IEEE 802.11
Wireless Access Method and Physical Specification

Title: **Proposed Revision to 94/068**
FHSS PLCP Sublayer - 2nd Edition

Date: July 11, 1994

This submission contains a proposed revision of section 3 of the FH PHY working draft standard as represented by document 94/068. This supersedes submission 94/103 which was not accepted in the May 1994 meeting. Note that even if this revision is adopted to replace section 3 of 94/068, it is still subject to detailed review and section-by-section voting by the FH PHY sub-group before presentation to the PHY group and the full 802.11 plenary. The changes fall into three categories:

Figure 9.2-1. PLCP Frame Format

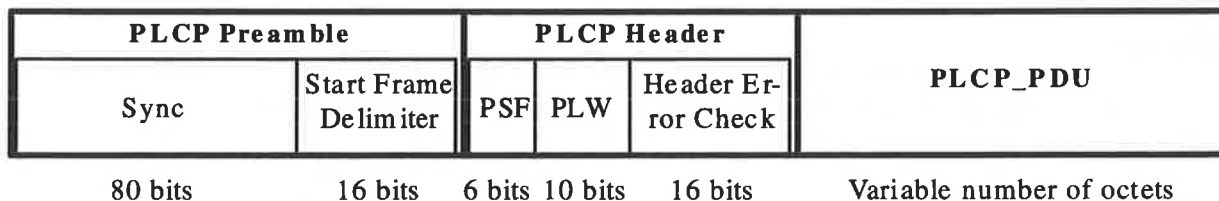
9.2.2 Physical Layer Convergence Procedure Frame Format (OPEN). ~~Doe-2xx~~ The PLCP Frame Format provides for the asynchronous transfer of MAC Layer MPDU from any transmitting node to all receiving nodes within the wireless LAN. The PLCP frame format illustrated in Figure 9.2-1 consists of three parts: a PLCP Preamble, a PLCP Header, and a PLCP PDU. The PLCP Preamble provides a period of time for several receiver functions. These functions include antenna diversity, clock and data recovery and data delineation of the PLCP Header and the PLCP PDU. The PLCP Header is used to specify the length of the MPDU field and support any PLCP management information. The PLCP PDU contains the MPDU data modified by the MPDU data whitener.

~~3.3 PLCP Field Definitions~~ The PLCP packet illustrated in Figure 3-1 contains three distinct fields: PLCP Preamble, PLCP Header, and the MPDU PLCP_PDU.

Figure 9.2-2 PLCP_PDU Data Whitener Format.
(17/16 encoding shown for example only; actual numbers are TBD)

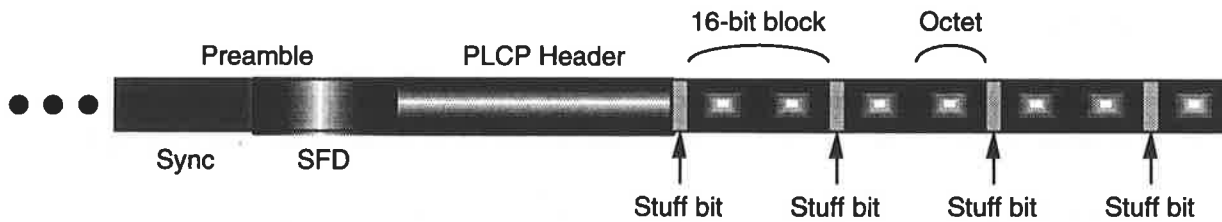
9.2.2.3 PLCP_PDU MPDU Data Whitener (OPEN). The PLCP_PDU data whitener uses a TBD scrambling and a TBD#/TBD# bias suppression encoding algorithm TBD scrambling/stuffing is used to randomize the data from highly redundant patterns and to minimize the data DC bias and maximum run lengths. The data whitening starts with the first bit of the PLCP_PDU which follows the last bit of the PLCP Header. The specific method used is TBD defined in section 9.2.3.1. The format of the packet after data whitening is as shown in Figure 9.2-2.

Figure 9.2-3 Transmit State Machine

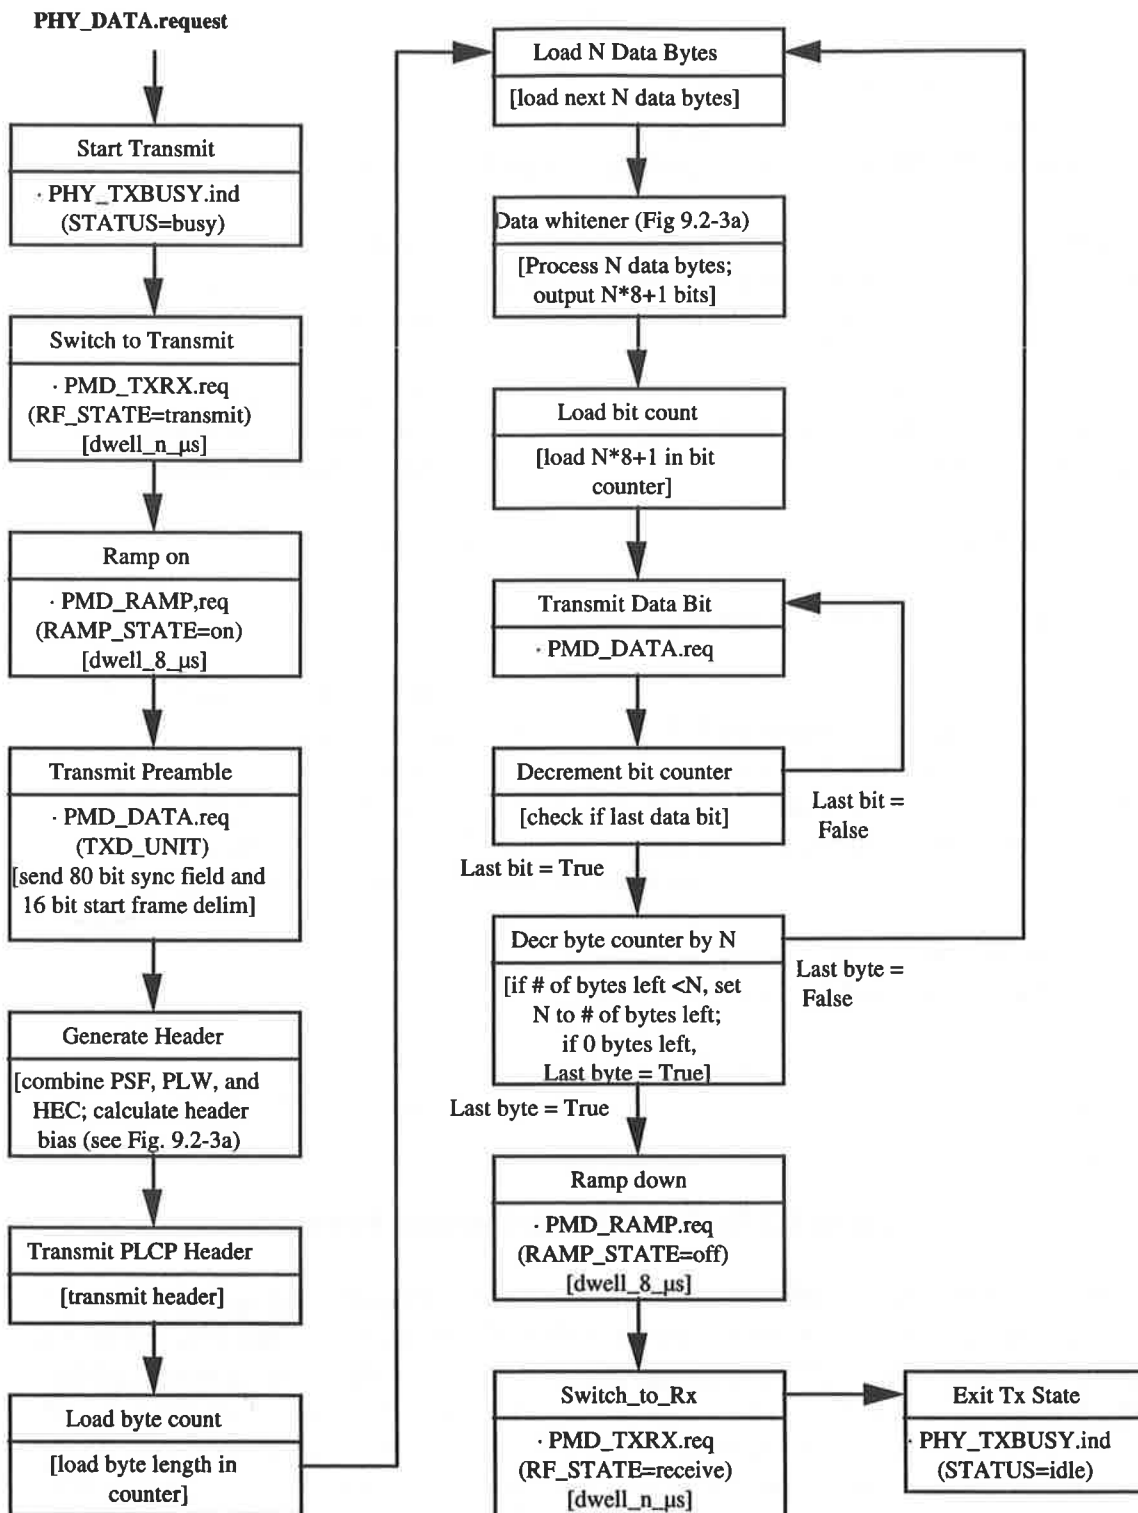
9.2.3.1 Transmit State Machine (OPEN). The PLCP transmit procedure illustrated in Figure 9.2-23 includes functions that must be performed prior to, during, and after MPDU data transmission. Before transmitting the first MPDU data bit, the PLCP shall send a PHY_TXBUSY.indicate (STATUS=busy) message to the MAC; switch the PHY PMD circuitry from receive to transmit state; ramp on the transmit power amplifier in the manner prescribed in Section 4 (PMD specification); and transmit the preamble sync pattern and start frame delimiter, and PLCP header. The PLCP shall generate the PLCP header as defined in Section 9.2.2.2 (PLCP Header) in sufficient time to send the bits at their designated bit slot time. The PLCP shall add the PLCP header to the start of the PLCP_PDU data. During transmission of the MPDU PLCP_PDU data, each bit of the MPDU passed down from the MAC shall be processed by the TBD scrambling/stuffing data whitening state machine defined in Figure 9.2-3a. and A counter shall be maintained to indicate the last bit of the MPDU. The PLCP_PDU data bytes are processed and transmitted MSB first and LSB last. After the last bit of the MPDU is sent PLCP_PDU data has completed propagation through the radio and been transmitted onto the air, the PLCP shall ramp turn off the power amplifier in the manner prescribed in the PMD section and send a PHY_TXBUSY.indicate(STATUS=idle) message to the MAC layer.

Figure 9.2-4 Transmit State Timing

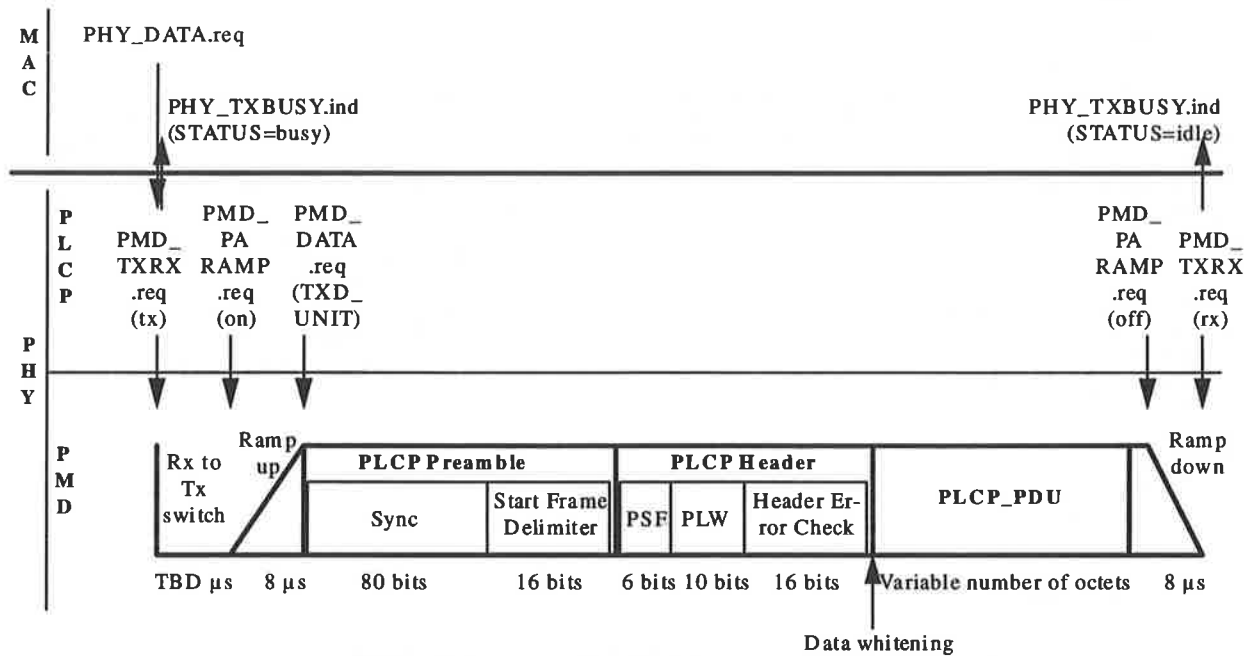
9.2.3.2 Transmit State Timing (OPEN). The transmit timing illustrated in Figure 9.2-4 is defined from the instant that the PHY_DATA.request is received from the MAC layer. The PLCP shall send a PHY_TXBUSY.indicate (STATUS=busy) message to the MAC within 1 μ s of receipt of the PHY_DATA.request. The PMD circuitry shall be switched from receive to transmit and settled within TBD μ s. The power amplifier shall be turned on and settled within the specified range about the final transmit power level 8 μ s after the receive to transmit switch time. The PLCP preamble shall be transmitted at 1 Mbps and be completed within 96 μ s. ~~The scrambling/stuffing~~ data whitening algorithm shall be enabled with the first bit following the preamble start frame delimiter and continue to the end of the MPDU. The PLCP header shall be transmitted at 1 Mbps and be completed within ~~TBD bit times~~ 32 μ s. The variable length ~~MPDU~~ PLCP_PDU shall be transmitted at the selected data

rate. Each byte of the MPDU data shall be sent with the most significant bit of each byte first and the least significant bit last. After the last bit of the MPDU PLCP PDU data has been transmitted completed propagation through the radio and been transmitted onto the air, the PLCP shall turn off the power amplifier and be less than the specified off-mode transmit power in 8 μs. At the end of the power amplifier ramp down period, the PLCP shall send a PHY_TXBUSY.indicate(STATUS=idle) message to the MAC layer and switch the PMD circuitry from transmit to receive. Upon completion of the transmit procedure, the PLCP shall return to the PLCP carrier sense procedure.

Figure 9.2-94 Receive State Machine

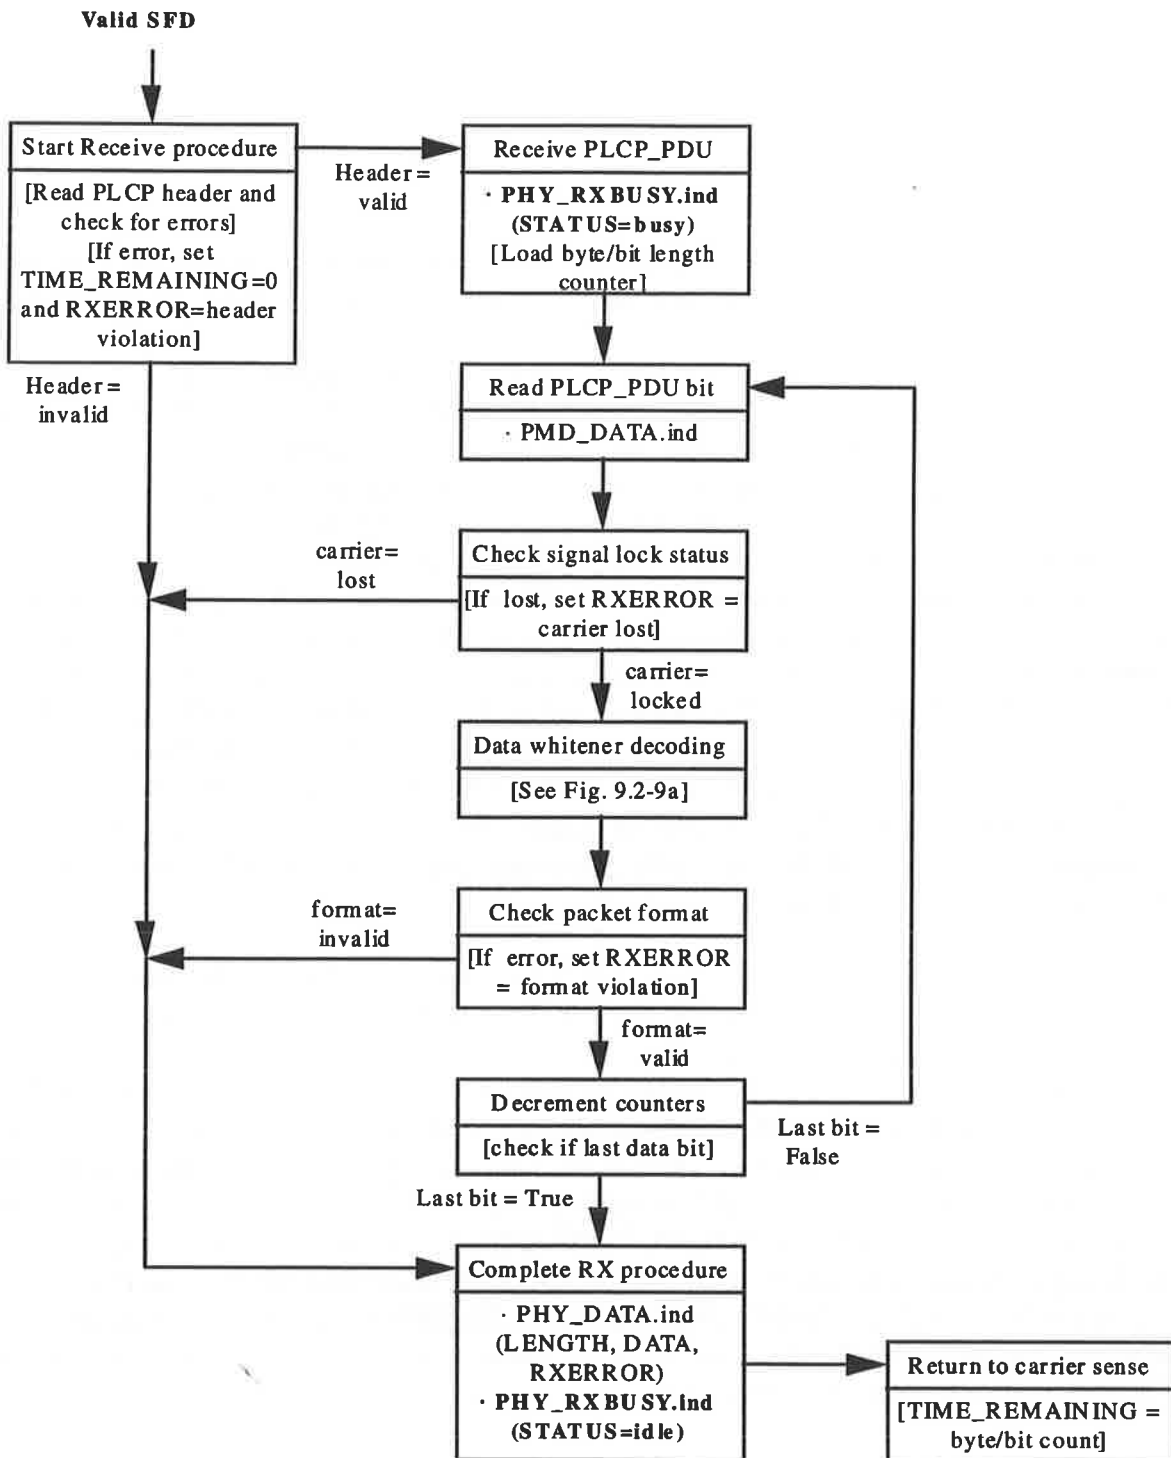
9.2.5.1 Receive State Machine (OPEN). The PLCP receive procedure shown in Figure 9.2-9 includes functions that must be performed while receiving the PLCP header and the ~~MPDU~~ PLCP PDU data. The PLCP receive procedure begins upon detection of a complete start frame delimiter in the carrier sense procedure. The PLCP shall read in the 32-bit PLCP header and perform an error check using the header error check field. Immediately upon detection of a valid PLCP header, start of the PLCP receive procedure the PLCP shall send a PHY_RXBUSY.indicate (STATUS=busy) message to the MAC layer. While receiving the PLCP header, the PLCP shall read the TBD length word, TBD PHY signaling field, and TBD FEC field, and perform a TBD error check/correction. If the PLCP header is free or corrected of errors, The PLCP shall set a PLCP PDU byte/bit counter to indicate the last bit of the packet, receive the MPDU PLCP PDU data bits and perform the TBD descrambling/unstuffing data whitening procedure shown in Figure 9.2-9a on each MPDU PLCP PDU bit. After the last MPDU PLCP PDU bit is received, the PLCP shall send a PHY_DATA.indicate(length, data) message and a PHY_RXBUSY.indicate (STATUS=idle) message to the MAC layer. Upon completion of receiving a packet, the PLCP shall exit the receive procedure and return to the PLCP carrier sense procedure with TIME_REMAINING=0.

If the PLCP header contains uncorrectable errors, the PLCP shall ~~send a PHY_RXERROR.indicate message to the MAC layer and exit the receive procedure~~ immediately set the byte/bit counter to zero, complete the receive procedure with a PHY_DATA.indicate(LENGTH=0, DATA=0, RXERROR=header violation) and a PHY_RXBUSY.indicate (STATUS=idle) to the MAC, and return to the carrier sense procedure with TIME_REMAINING=0. If the signal is interrupted for any reason, the PLCP shall immediately complete the receive procedure with a PHY_DATA.indicate(LENGTH, DATA, RXERROR=carrier lost) and a PHY_RXBUSY.indicate (STATUS=idle) to the MAC, and return to the carrier sense procedure with TIME_REMAINING= byte/bit count remaining. If any other error was detected during the reception of the packet, the PLCP shall immediately complete the receive procedure with a PHY_DATA.indicate(LENGTH, DATA, RXERROR=header violation) and a PHY_RXBUSY.indicate (STATUS=idle) to the MAC, and return to the carrier sense procedure with TIME_REMAINING=byte/bit count remaining.

Figure 9.2-105 Receive Timing

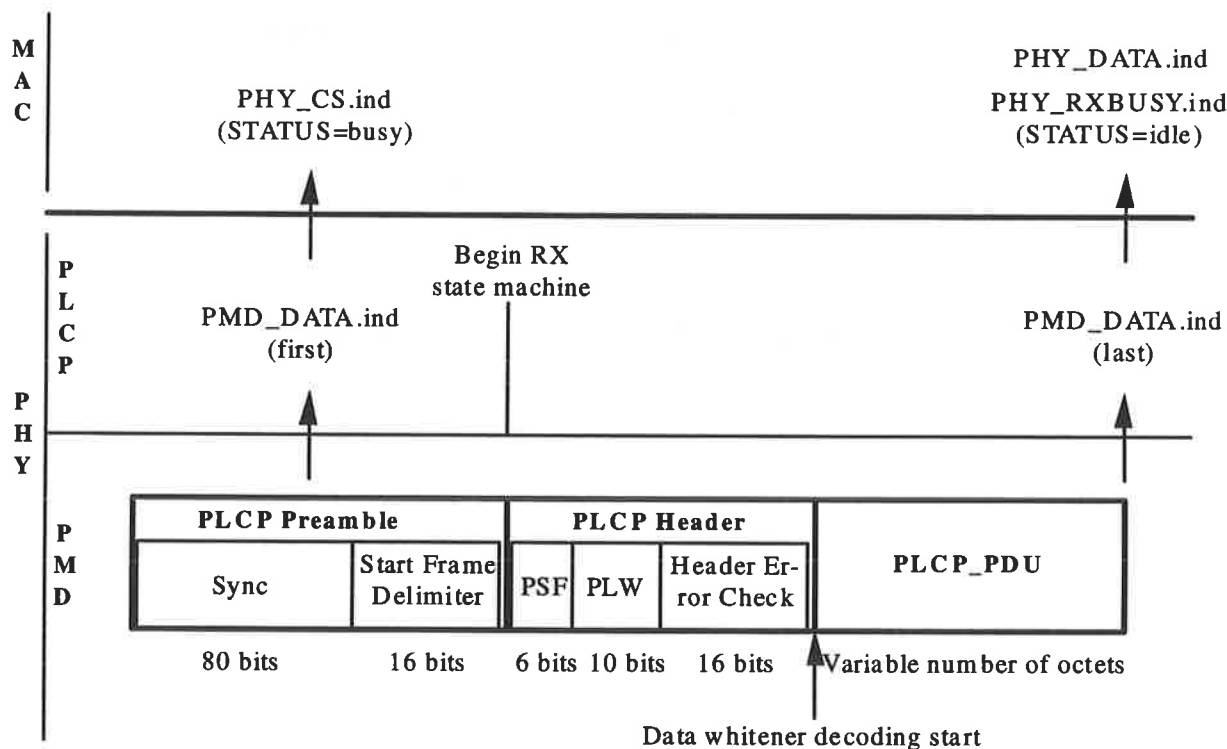
9.2.5.2 Receive State Timing (OPEN). The receive state timing shown in Figure 9.2-10 is defined at the end of the last bit of the to begin upon detection of a complete start frame delimiter in the carrier sense procedure when the PMD FDET is generated. The PLCP shall read in the PLCP header and generate a PHY_RXBUSY.indicate message to the MAC layer within 1 μ s of receiving the last bit of a valid PLCP header. The PLCP shall read in the TBD MPDU length indicator and TBD PHY signaling field of the PLCP header and calculate and preload the byte/bit count in the counter within TBD of prior to the last bit of a valid PLCP header the length indicator. The PLCP shall read in the TBD header error check field and perform the check within TBD μ s of the last bit of the error check field. The PLCP shall begin receiving the variable length MPDU PLCP PDU immediately after the end of the last bit of the PLCP header. The PLCP shall send the PHY_RXBUSY.indicate (STATUS=idle) and PHY_DATA.indicate messages within 1 μ s of receiving the last PLCP PDU data bit.

If there was an uncorrectable error in the PLCP header, the PLCP shall terminate the receive procedure within TBD μ s of the start end of the MPDU PLCP header. If any other error was detected during the reception of the packet, the PLCP shall terminate the receive procedure within TBD μ s of detecting the error.
